SUBJECT: REVIEW OF INTERIM REMEDIAL ACTION PLAN FOR EAST ADJACENT PROPERTIES, PURSUANT TO CALIFORNIA WATER CODE SECTION 13304 CLEANUP AND ABATEMENT ORDER NO. R4-2021-0079

SITE: SKYPARK COMMERCIAL PROPERTIES (ASSESSOR PARCEL NO. 7377-006-906), 24701 – 24777 CRENSHAW BOULEVARD AND 2530, 2540, AND 2600 SKYPARK DRIVE, TORRANCE, CALIFORNIA (SCP NO. 1499)

On February 28, 2022, the Los Angeles Water Board staff received the *Removal Action Workplan for the East Adjacent Properties* (EAP IRAP), submitted on behalf of the City of Torrance by Terraphase Engineering Inc. (Terraphase) for review.

Attachment 1 - Figure 19 – Proposed Additional Soil Vapor Sampling

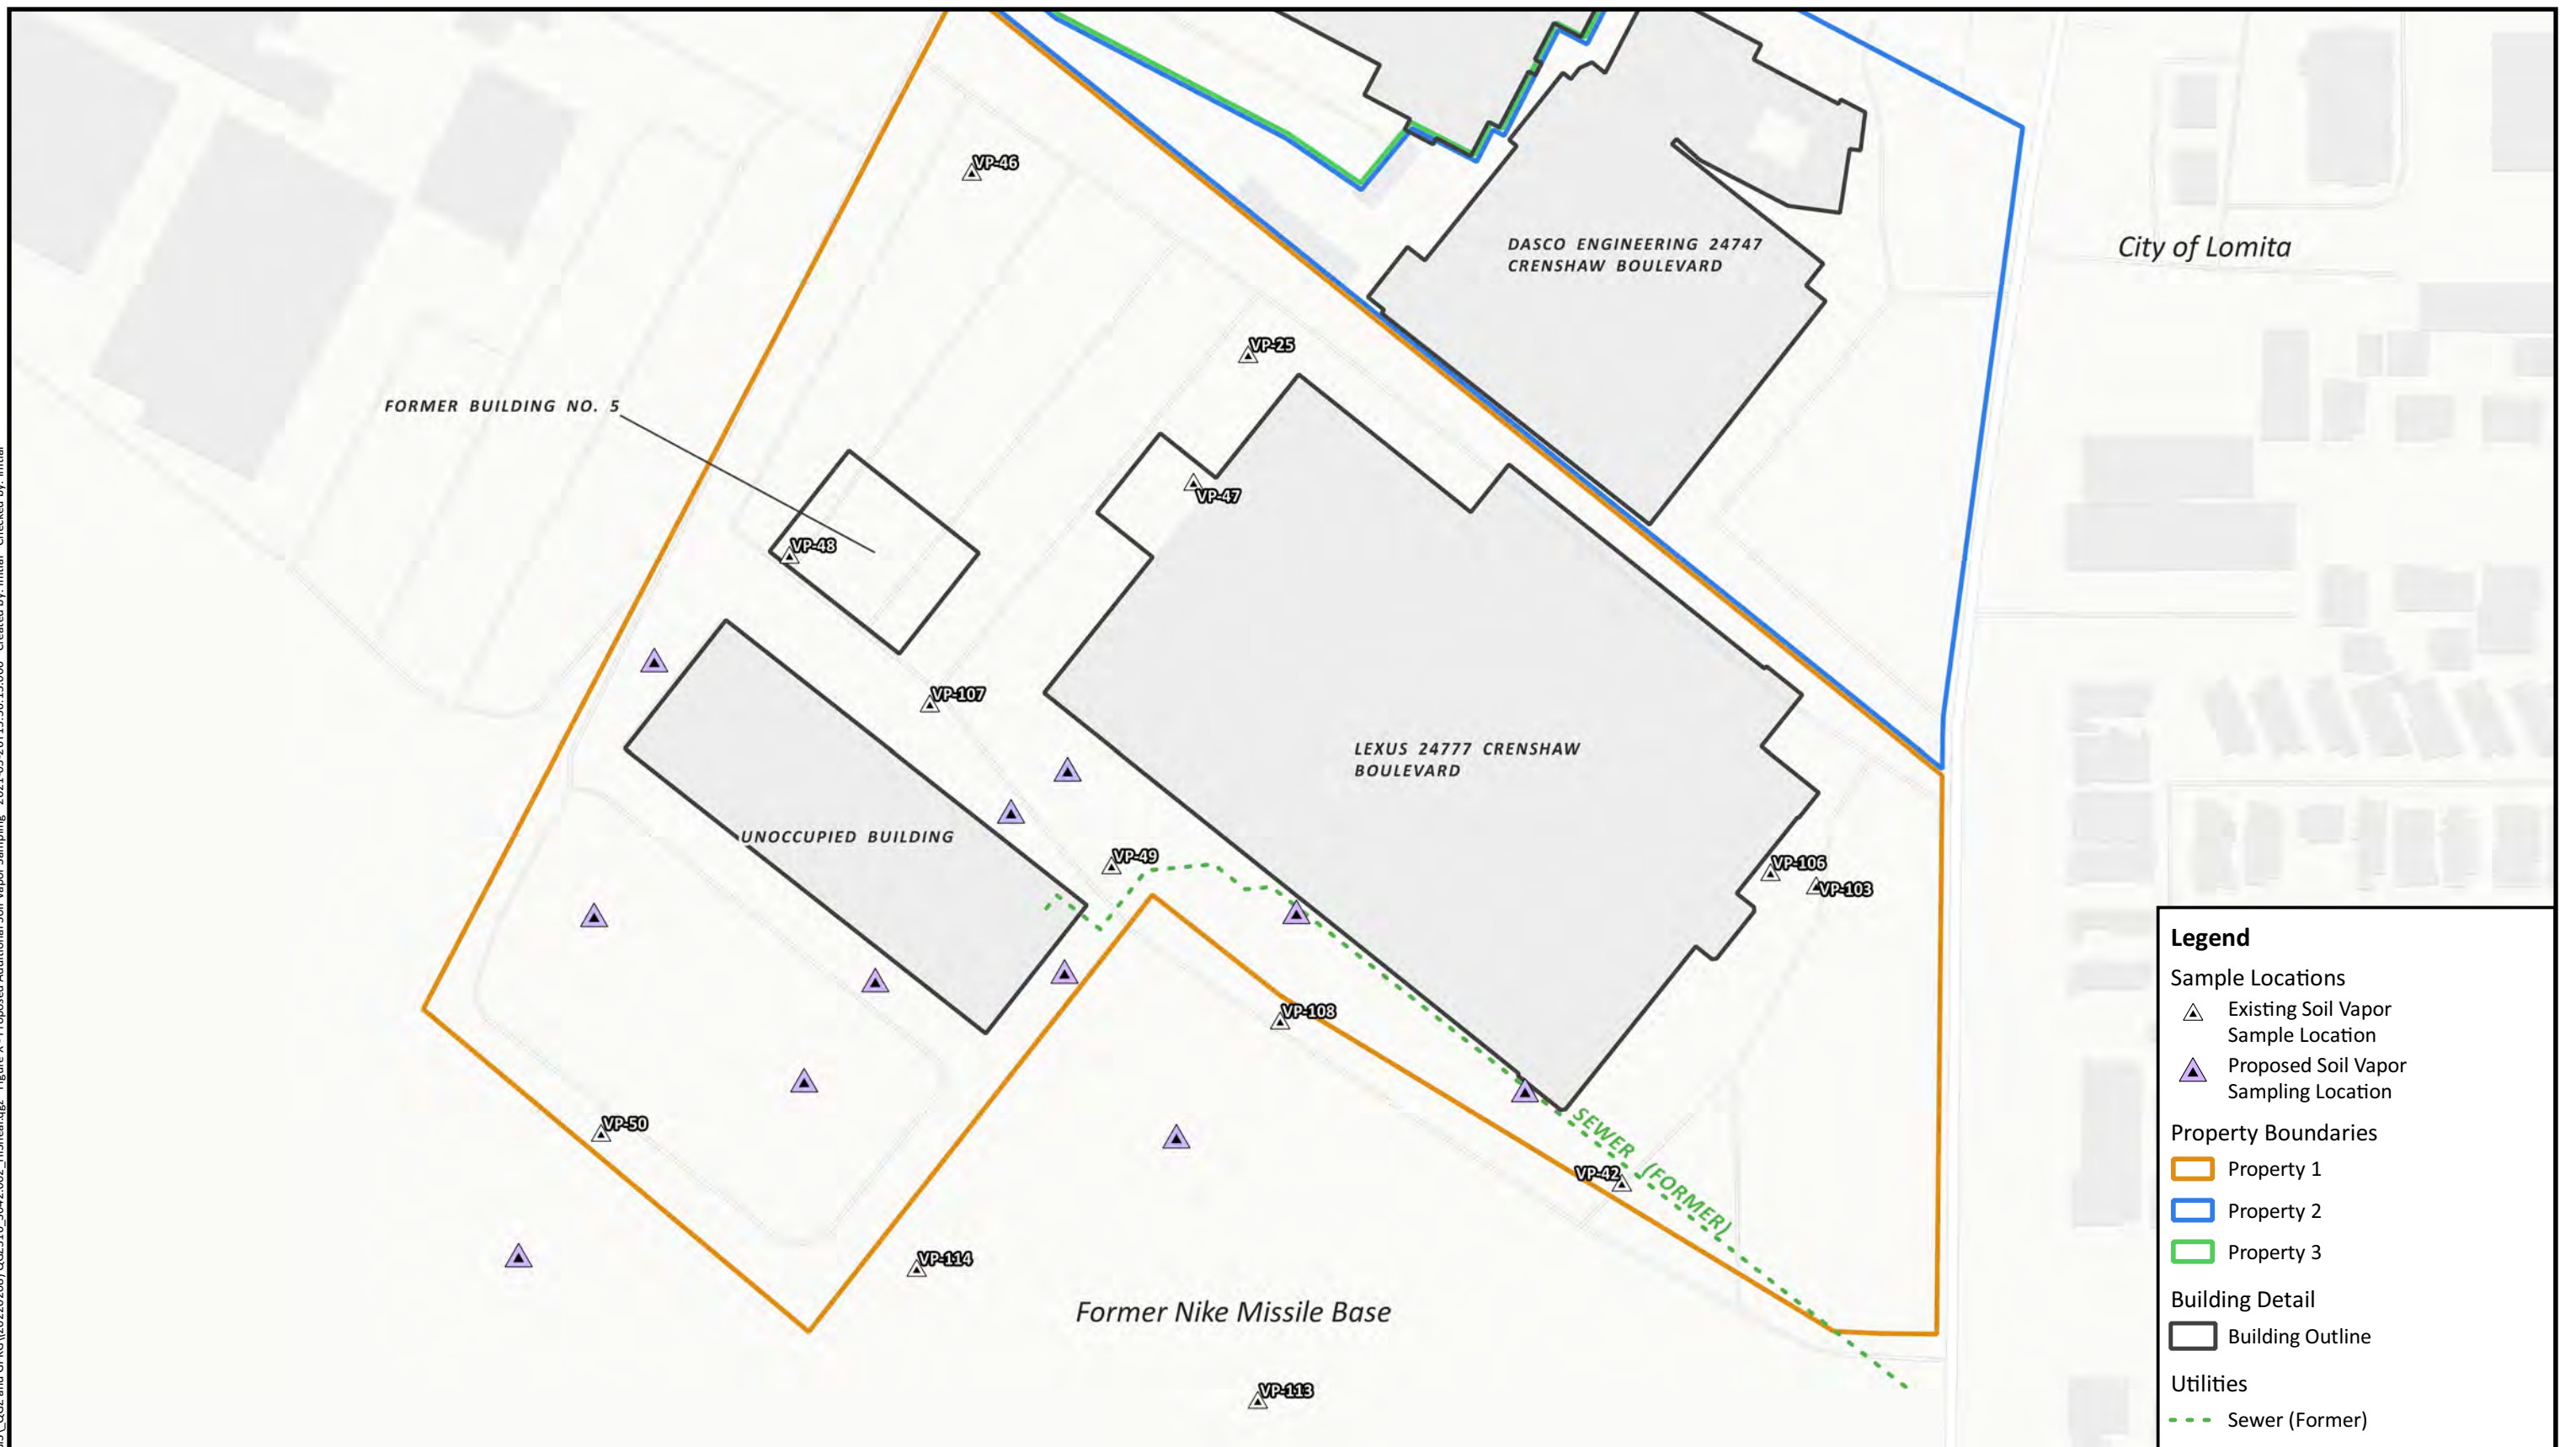
1. The Los Angeles Water Board concurs with the proposed investigative component of the EAP IRAP; however, the investigative activities proposed should not be performed sequentially but rather concurrently with selected interim remedial activities, upon approval. The investigative component proposed in the EAP IRAP

does not completely delineate the Site and additional investigative and assessment activities may be warranted following its implementation.

- a. Soil samples should be collected at 5 ft-bgs at 5-foot intervals to groundwater during the perched and regional groundwater investigations (i.e., advancement of five soil borings to perched groundwater or 70 ft-bgs, advancement of 20 soil borings to regional groundwater, installation of three perched and five regional groundwater monitoring wells) and submitted for laboratory analysis of VOCs.

Attachment 2 - Figure 20 – Proposed Groundwater Sampling Locations

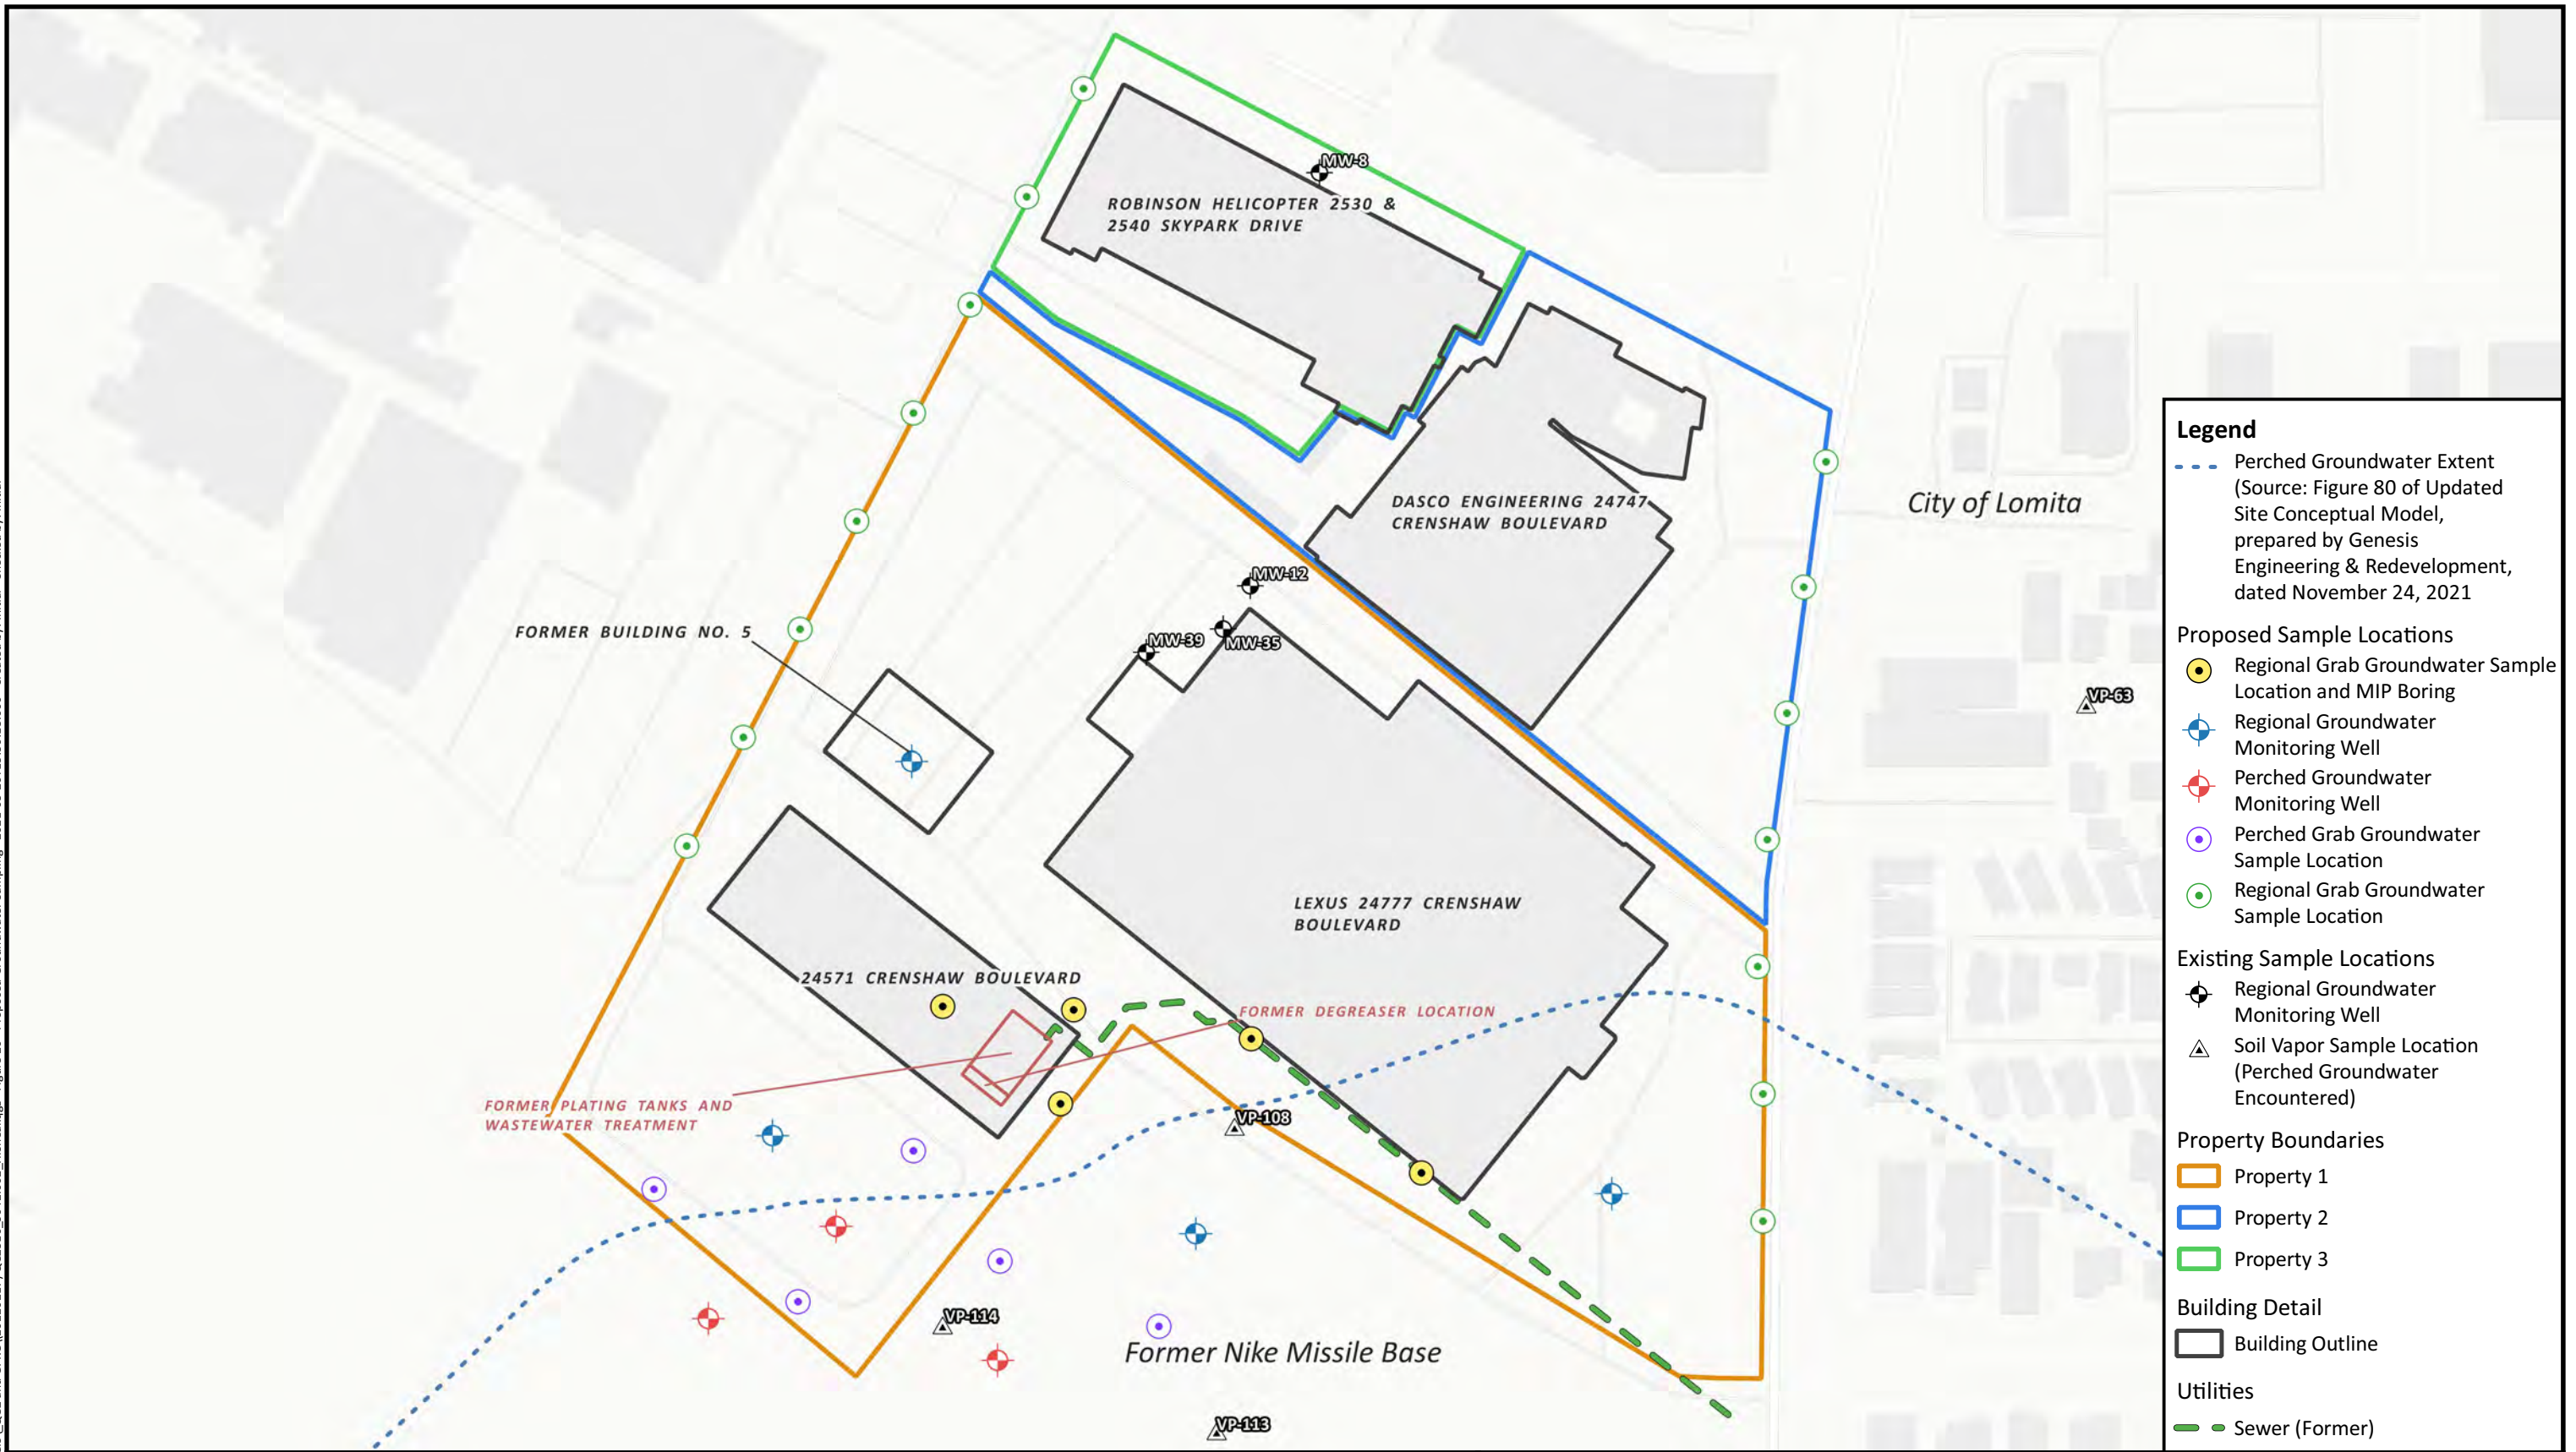
- a. *Table 2 – Data Gap Investigation Cost Estimate* does not budget for the soil borings advanced with MIP.
 - b. *Table 2 – Data Gap Investigation Cost Estimate* in the EAP IRAP shows two perched groundwater monitoring wells are budgeted for installation. However, the text of the IRAP proposes the installation of three perched groundwater monitoring wells and Figure 20 depicts three perched groundwater monitoring wells.

- c. *Table 2 – Data Gap Investigation Cost Estimate* show four regional groundwater monitoring wells are budgeted for installation and Figure 20 depicts four regional groundwater monitoring wells. However, the text of the EAP IRAP proposes the installation of five regional groundwater monitoring wells. The proposed groundwater monitoring well on Property 2 is not included in Figure 20 and Figure 21 of the EAP IRAP.
